Z.C. Case No. 15-14

Comments on behalf of Forest City

EXHIBIT A
APPROVED 1 1/2 STREET DESIGN

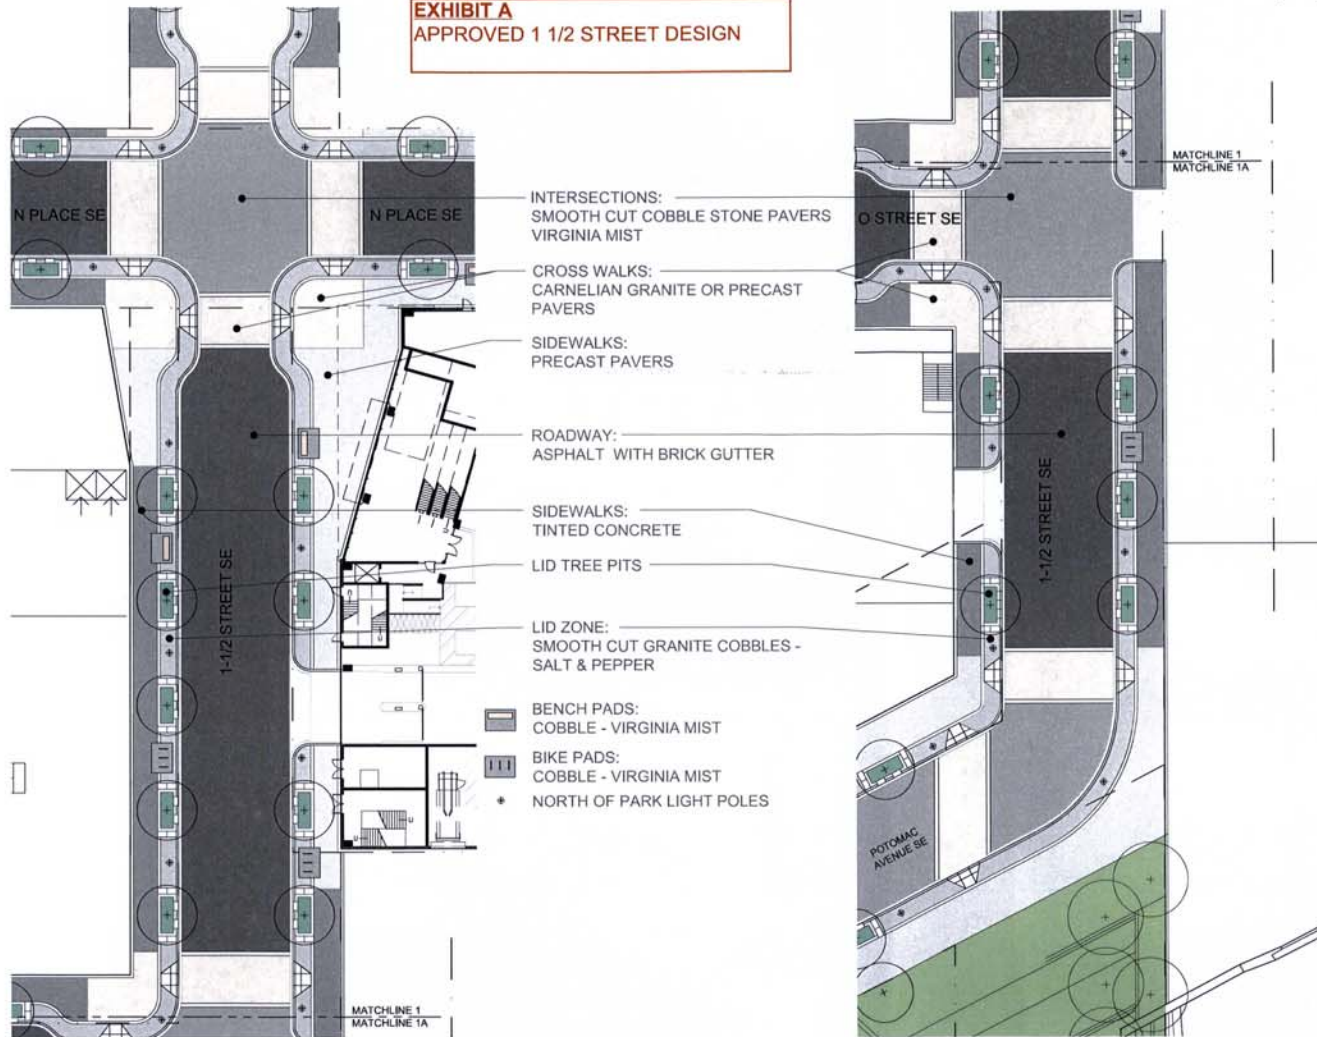
In the Forest City PUD, the Commission approved the design of a proposed 1 ½ Street that would run as a north-south spine from the Anacostia River, through the PUD, and continue north into The Yards. The approved 1 ½ Street is shown on Exhibit A. It has a right-of-way of 70 feet, with sidewalks, street trees, parking and travel lanes. The entirety of 1 ½ Street was presumed to be a part of the Forest City PUD and connects to the Forest City-controlled parcels in The Yards north of N Place.

Forest City also notes that DC Water's proposed street dimensions differ from the previously-approved dimensions for 1 ½ Street. The proposed right-of-way would be narrowed, eliminating the parking lanes and jogging the curb line further west. This also causes the sidewalk itself to jog further west. Forest City has no objection in principle to the proposed alteration to the previously-approved plan, so long as it maintains a continuous, useable, and publicly accessible sidewalk on the east side of 1 ½ Street from the Anacostia River up to the parcel to the north.

POST FOREST CITY PUD CONDITIONS: SITE PLAN

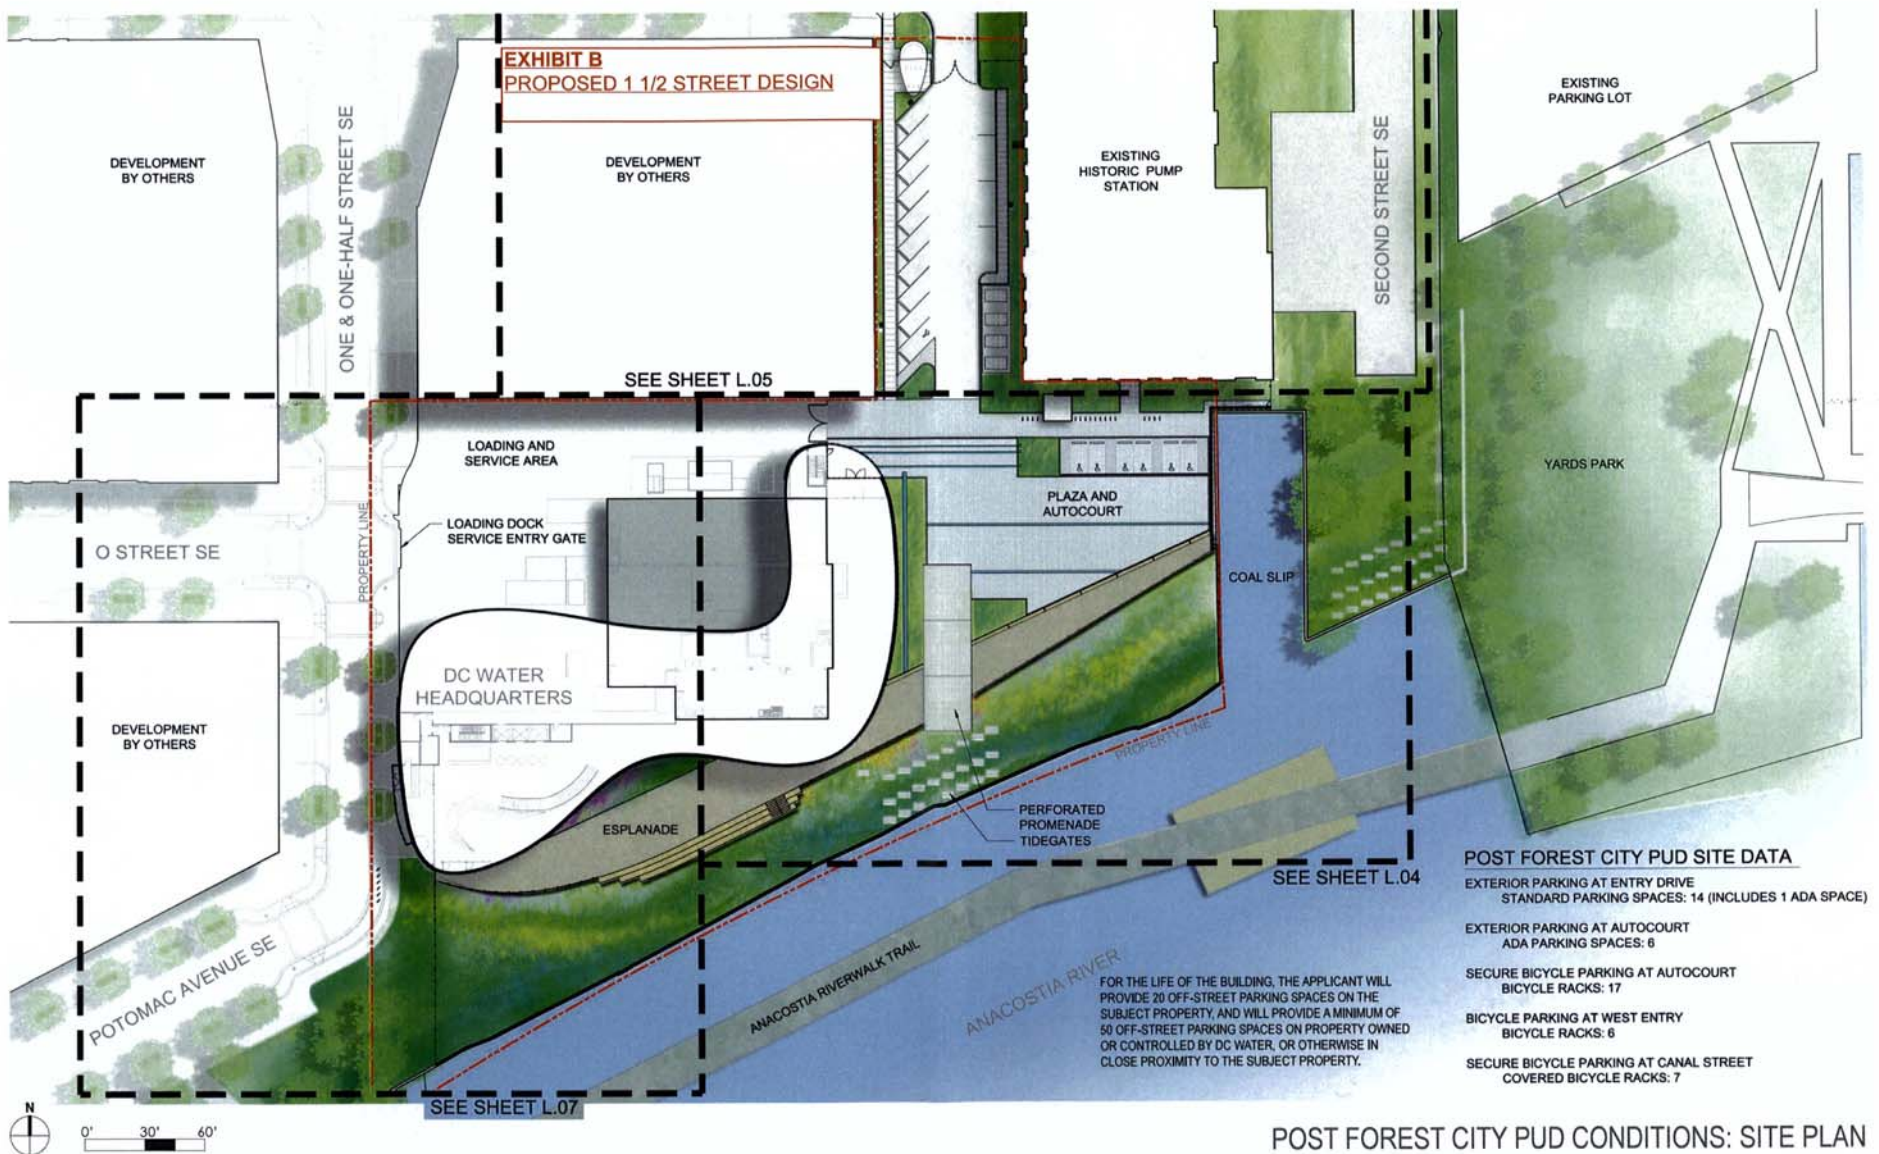
DC Water's PUD includes the eastern portion of 1 ½ Street within its boundaries, as shown on Exhibit B. Forest City does not object to DC Water taking responsibility for constructing and maintaining this portion of the street, but wants to ensure that it is consistent with the remainder of the streetscape design. To that end, Forest City asks that DC Water agree to use the materials, design, and layout for 1 ½ Street per Forest City's approved PUD, agree to maintain its portion of the streetscape, and agree to construct its portion of the streetscape in coordination with Forest City's phased buildout of 1 ½ Street.
